**WCAP-16996-P, "Realistic LOCA Evaluation Methodology Applied to the Full Spectrum of Break Sizes  
(FULL SPECTRUM LOCA Methodology)"  
Requests for Additional Information – Second Set (Non-Proprietary)**

**May 2013**

Westinghouse Electric Company LLC  
1000 Westinghouse Drive  
Cranberry Township, PA 16066

Figure: ANSI/ANS 5.1-1979 Tabular Data for Standard Decay Heat Power and Uncertainty for Thermal Fission of  $^{235}\text{U}$  and  $^{239}\text{Pu}$  and Fast Fission of  $^{238}\text{U}$  for Irradiation of  $10^{13}$  s

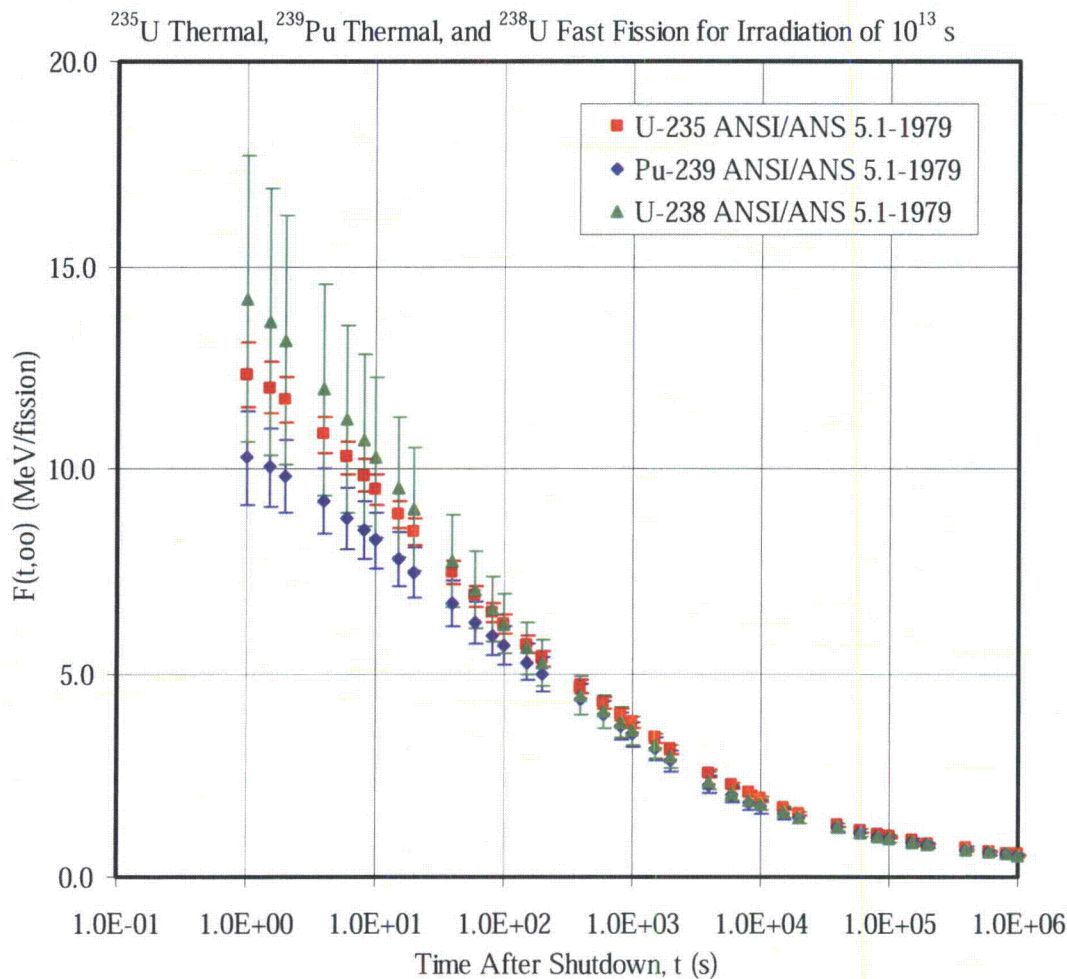
- (1) It is believed that the units for decay heat on the Y-axis in each figure should be "MeV/fission" (MeV/fission=[MeV/s]/[fission/s]). Instead, the decay heat units appear as "MeV/sec/fission".
- (2) It appears that that Figure 9-26 exhibits the decay heat function  $F_i(t,T)$  for thermal fission of  $^{235}\text{U}$ , Figure 9-27 plots  $F_i(t,T)$  for thermal fission of  $^{239}\text{Pu}$ , and Figure 9-28 shows  $F_i(t,T)$  for fast fission of  $^{238}\text{U}$  for infinite irradiation time ( $T=10^{13}$  s) in all three plots. However, description for the plotted quantities is not provided in Section 9.7.
- (3) Only two data sets (curves) are seen in each of the plots. A third data set (curve) is not distinguishable and using symbols to indicate overlapping curves can be used if appropriate.

Please provide updated plots that represent the WCOBRA/TRAC-TF2 decay heat predictions for  $^{235}\text{U}$ ,  $^{239}\text{Pu}$ , and  $^{238}\text{U}$  for decay time from 0.1 s to  $10^6$  s. In each plot, please show the standard decay heat values  $F_i(t,\infty)$  for  $^{235}\text{U}$ ,  $^{239}\text{Pu}$ , and  $^{238}\text{U}$  as tabulated in ANSI/ANS 5.1-1979 Tables 4, 5, and 6 representing each value by a symbol with a two-sided Y-error bar corresponding to  $\pm 2\sigma$  uncertainty using the uncertainty data in the ANSI/ANS 5.1-1979 tables. The uncertainties in both ANSI/ANS 5.1-1979 and ANSI/ANS 5.1-2005 are currently represented in tabular form for the decay heat functions  $f_i(t)$  and  $F_i(t,\infty)$  and values for intermediate times are obtained by interpolation. The included figure presents the  $F_i(t,\infty)$  ANSI/ANS 5.1-1979 Standard decay heat and uncertainty data for  $^{235}\text{U}$ ,  $^{239}\text{Pu}$ , and  $^{238}\text{U}$ . In each figure, plot a curve that shows the "nominal" WCOBRA/TRAC-TF2 decay heat prediction as a continuous function of time and then show two additional curves that represent uncertainties predicted by WCOBRA/TRAC-TF2 and representing the decay heat "upper bound" (nominal plus  $2\sigma$ ) and "lower bound" (nominal minus  $2\sigma$ ). Explain how the code predicts the uncertainties for  $t < 1$  s as no standard data are provided.

- (1) The units for decay heat power on the Y-axis in Figures 9-26 through 9-28 should be MeV/fission.
- (2) Figures 9-26 through 9-28 display the comparison of decay heat power functions  $F_1(t,T)$  for thermal fission of  $^{235}\text{U}$ , thermal fission of  $^{239}\text{Pu}$ , and fast fission of  $^{238}\text{U}$  for infinite irradiation time calculated with WCOBRA/TRAC-TF2 and the ANSI/ANS-5.1-1979 standard.
- (3) See Figures RAI-21-1 through RAI-21-3 for updated plots with more visible lines.

Figures RAI-21-1 through RAI-21-3 provide curves that represent the nominal WCOBRA/TRAC-TF2 decay heat power predictions as continuous functions of time, as well as two additional curves that represent the decay heat power "upper bound" (nominal plus  $2\sigma$ ) and "lower bound" (nominal minus  $2\sigma$ ) for  $^{235}\text{U}$ ,  $^{239}\text{Pu}$ , and  $^{238}\text{U}$  for decay time from 0.1 s to  $10^6$  s. In addition, each plot includes the standard

Figure: ANSI/ANS 5.1-1979 Tabular Data for Standard Decay Heat Power Uncertainty for Thermal Fission of  $^{235}\text{U}$  and  $^{239}\text{Pu}$  and Fast Fission of  $^{238}\text{U}$  for Irradiation of  $10^{13}$  s

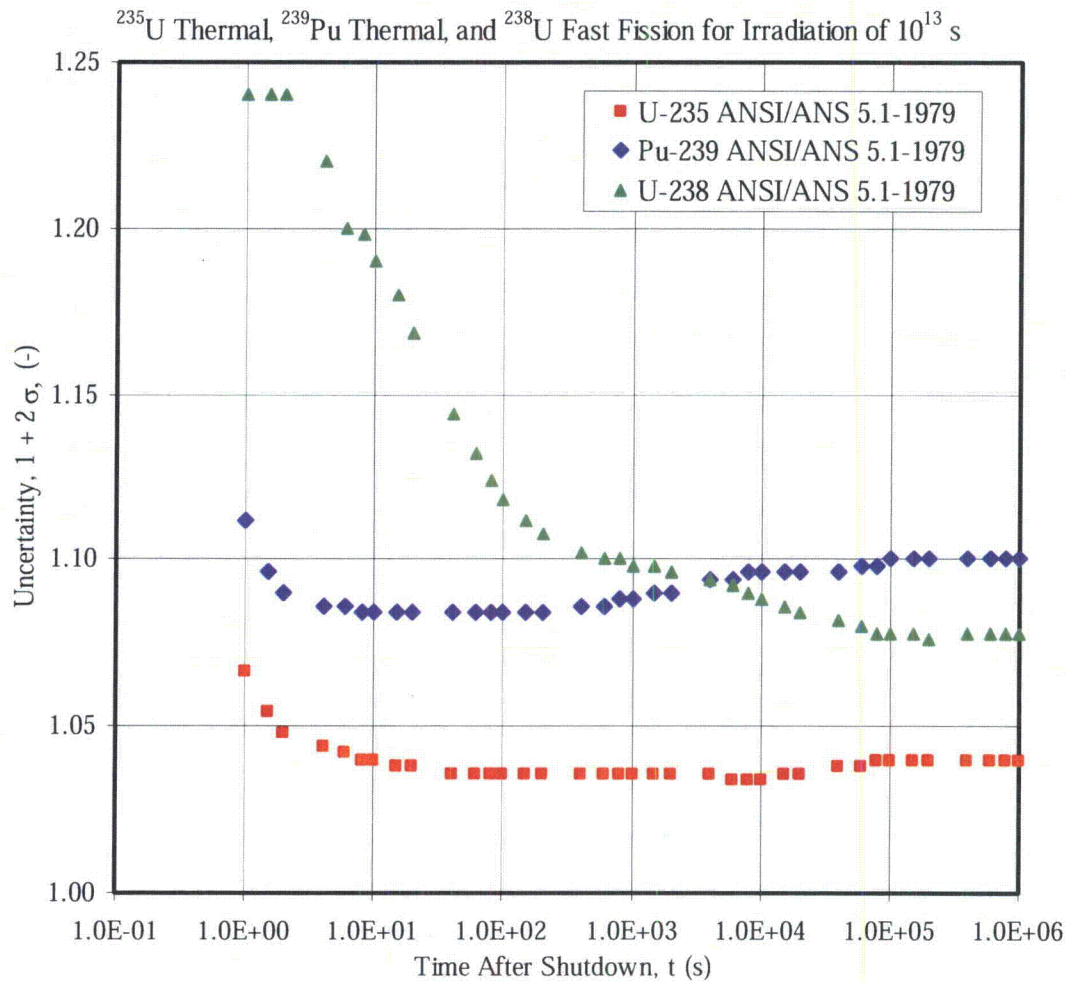
It is seen from Figures 9-23 to 9-25 that the plotted discrepancies exhibit most pronounced deviation during the first 100 s of cooling time. At the same time, approximately 25% of the residual decay energy is released in the first 10 s after the fission process ends and about 50% is released by 100 s after fission (see I. Gauld, "Validation of ORIGEN-S Decay Heat Predictions for LOCA Analysis," PHYSOR-2006, ANS Topical Meeting on Reactor Physics, Vancouver, BC, Canada, September 10-14, 2006).

Please explain how the quantity labeled "Deviation" and shown along the vertical Y-axis in Figures 9-23 to 9-25 for cooling time from  $10^{-1}$  s to  $10^9$  s was computed and define the parameters "energy" and "decay heat" for which the results were plotted. Please provide updated plots that compare the WCOBRA/TRAC-TF2 uncertainty predictions for  $^{235}\text{U}$ ,  $^{239}\text{Pu}$ , and  $^{238}\text{U}$  for cooling time from 0.1 s to  $10^6$  s. In each plot, please show the uncertainty presented as  $1+2\sigma$  and computed using the tabulated  $\sigma$  uncertainty percent values provided in ANSI/ANS 5.1-1979 Tables 4, 5, and 6. The included figure presents the ANSI/ANS 5.1-1979 Standard decay heat uncertainty data for  $^{235}\text{U}$ ,  $^{239}\text{Pu}$ , and  $^{238}\text{U}$ . In each figure, plot a curve that shows the WCOBRA/TRAC-TF2 decay heat uncertainty prediction as a continuous function of time. Explain how the code predicts the uncertainties for  $t < 1$  s as no standard uncertainty data are provided. If the WCOBRA/TRAC-TF2 decay heat uncertainty model underestimates any of the ANSI/ANS 5.1-1979 Standard values, a correction factor needs to be implemented to ensure that the code calculates uncertainties that are not less than the standard values.

The lines designated as decay heat in Figures 9-23 through 9-25 represent the percent deviation between the WCOBRA/TRAC-TF2 decay heat power predictions in Mev/fission and the standard decay heat power values  $F_i(t, \infty)$  from ANSI/ANS 5.1-1979 in Mev/fission. The percent deviation is calculated according to Equation (1).

Figures RAI-22-1 through RAI-22-3 show the nominal WCOBRA/TRAC-TF2 decay heat power predictions plus  $2\sigma$  uncertainty as continuous functions of time for  $^{235}\text{U}$ ,  $^{239}\text{Pu}$ , and  $^{238}\text{U}$ , presented normalized to the nominal values. In addition, the ANSI/ANS 5.1-1979 standard decay heat power uncertainty data for  $^{235}\text{U}$ ,  $^{239}\text{Pu}$ , and  $^{238}\text{U}$  is presented in the same format.
